STAFF RECOMMENDATION 3713 Richland Avenue June 19, 2013

Application: New Construction—Addition; Setback reduction
District: Richland-West End Neighborhood Conservation Zoning Overlay
Council District: 24
Map and Parcel Number: 10409011700
Applicant: Preston Quirk
Project Lead: Melissa Baldock, melissa.baldock@nashville.gov

<p>Description of Project: Application is to construct an attached carport that requires a setback reduction.</p> <p>Recommendation Summary: Staff recommends approval of the project, finding that the carport and setback reduction meet Section II.B.1. and II.B.2. of the <i>Richland-West End Neighborhood Conservation Zoning Overlay: Handbook and Design Guidelines</i>.</p>	<p>Attachments A: Photographs B: Site Plan C: Elevations</p>
--	--

Side of the house beyond the porte cochere

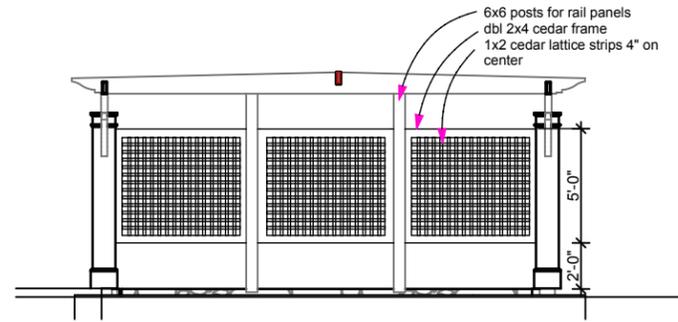
The carport will attach to the screened porch at the rear of the house. Its roof will match the porch floor height.

A2
SHEET 9

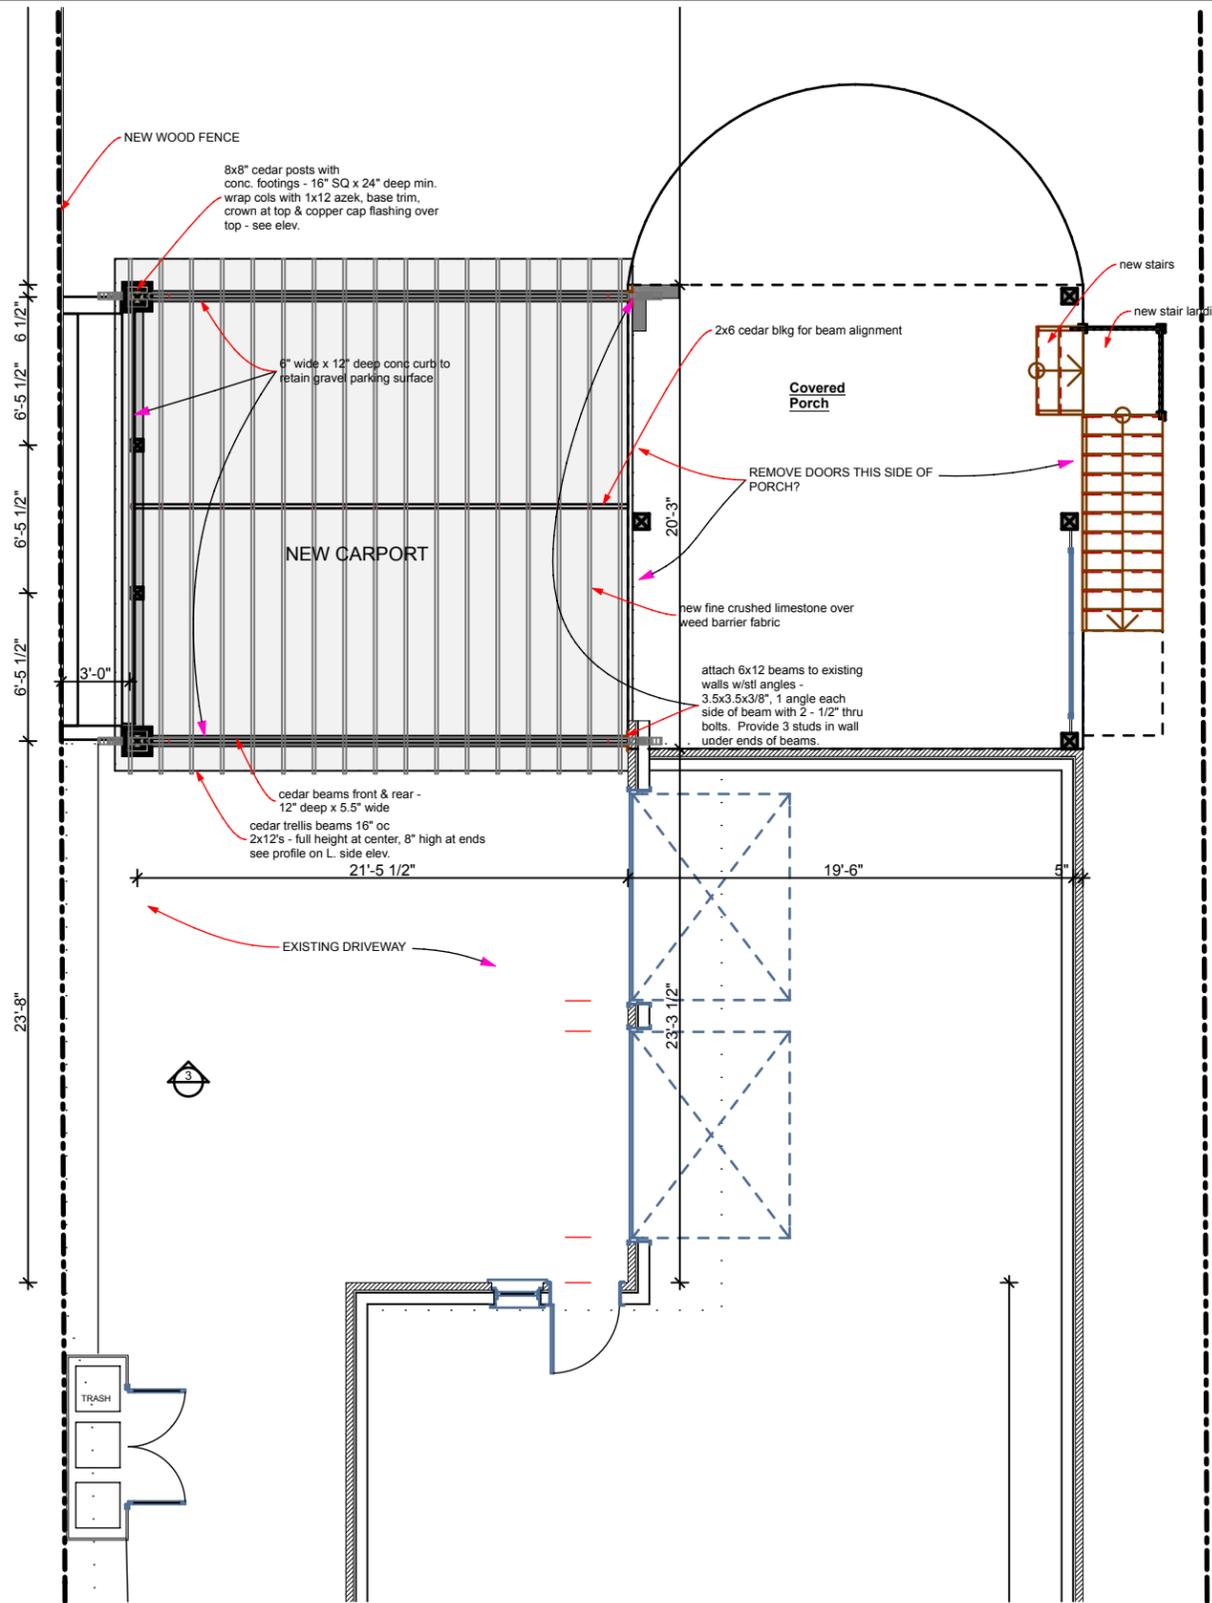
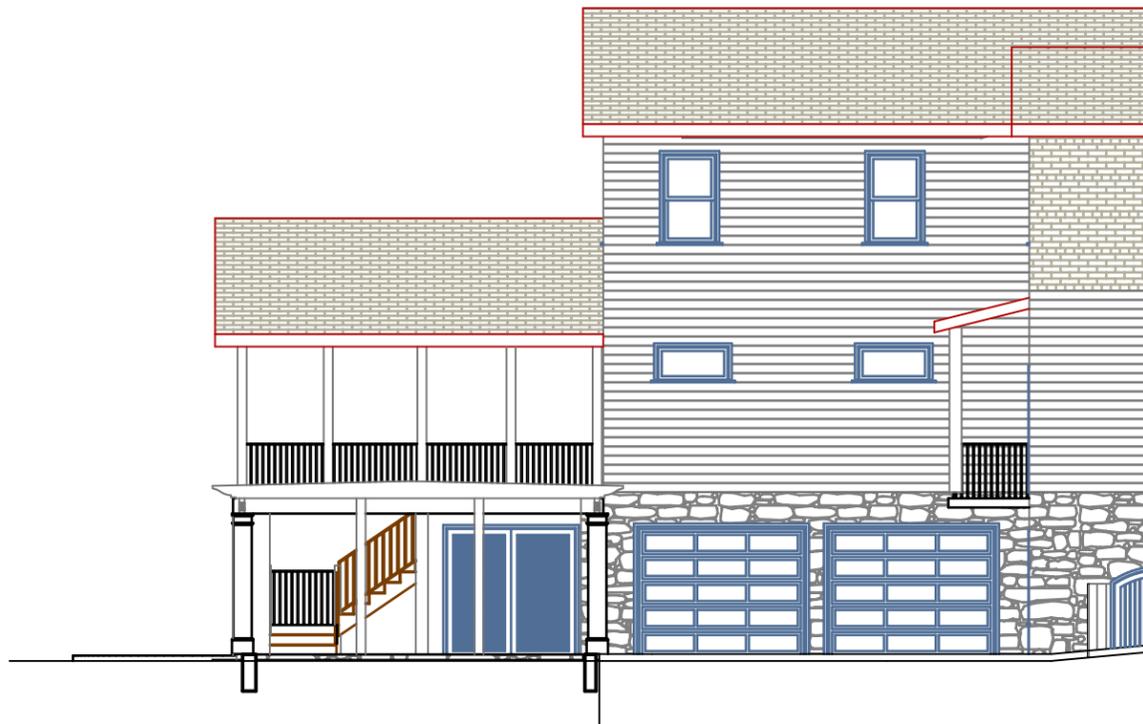
Location, Setback: The proposed carport addition is attached to a non-historic covered porch portion of the house at the rear. It will be accessed via an existing driveway. The carport will extend beyond the main body of the house, but will be located in line with the existing porte cochere at the front of the house. The carport will be no wider than the existing porte cochere. The carport requires a setback reduction. Base zoning requires that the structure be at least five feet (5') from the side property line, but the structure is proposed to be only three feet (3'). Staff finds the proposed setback reduction to be appropriate in this instance because it lines up with the existing porte cochere, which also does not meet the required five foot (5') setback. Staff finds that the location and setback for the proposed addition meet Section II.B.1c. and II.B.2. of the design guidelines.

The existing house is approximately thirty-two feet, six inches (32'6") wide not including the porte cochere. With the porte cochere, the house is forty-two feet, six inches (42'6") wide. The house is one hundred and eleven feet (111') deep, and the carport will not increase the depth of the house. The addition attaches to the non-historic porch addition that is inset twelve feet, six inches (12'6") from the left sidewall of the house. The carport is twenty-one feet, five and a half inches (21'5½") wide and twenty feet, three inches (20'3") deep. The carport extends approximately eight feet, six inches (8'6") beyond the sidewall of the house, matching the line of the porte cochere at the front of the house.

A3
SHEET 10

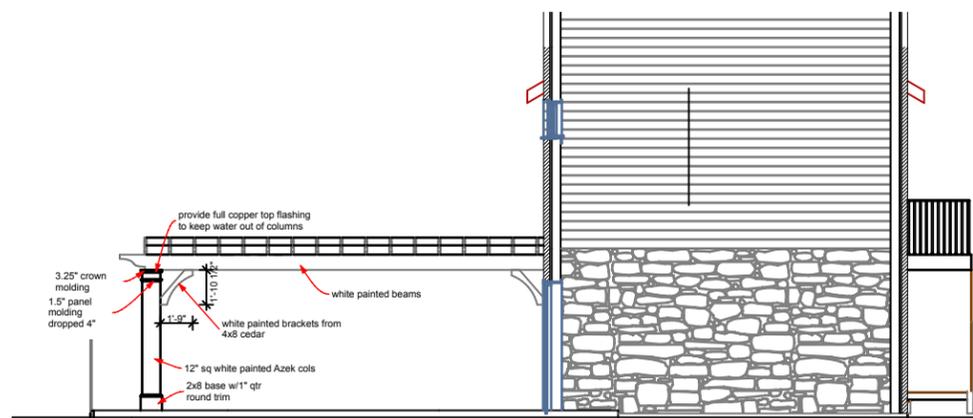
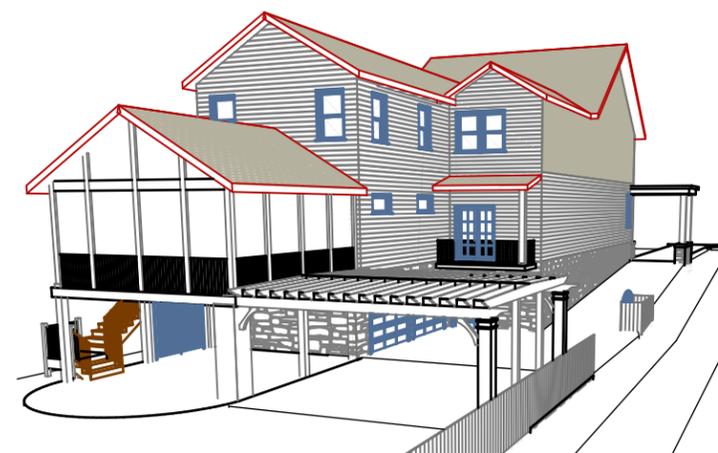
Height, Scale: The existing house is two and a half stories tall and has a ridge height of approximately thirty-five feet (35') and an eave height of approximately twenty-eight feet (28'). The addition will be one story and significantly shorter than the house. Because of the slope of the site, the roof of the carport will be approximately in line with the house's foundation line.. It will have a maximum height of approximately nine feet, nine inches (9'9").

Materials: The new carport will be constructed of cedar posts with Azek columns that include a cap and a base. The roof will have cedar trellis beams and will not be covered. The structure will remain open on all sides. Staff finds that these materials meet Sections II.B.1.d and II.B.2. of the design guidelines

Roof Form: The existing house's primary roof form is a side gable. The front porte cochere's roof ties into the porch roof and is flat. The proposed carport will also have a flat roof, which is appropriate for its use and because it matches the front porte cochere. Staff finds that the roof form meets Sections II.B.1.e. and II.B.2. of the design guidelines.

Proportion and Rhythm of Openings: The carport will be open on all three sides, which is appropriate. Staff therefore finds that it meets Section II.B.1.g. and II.B.2. of the design guidelines.
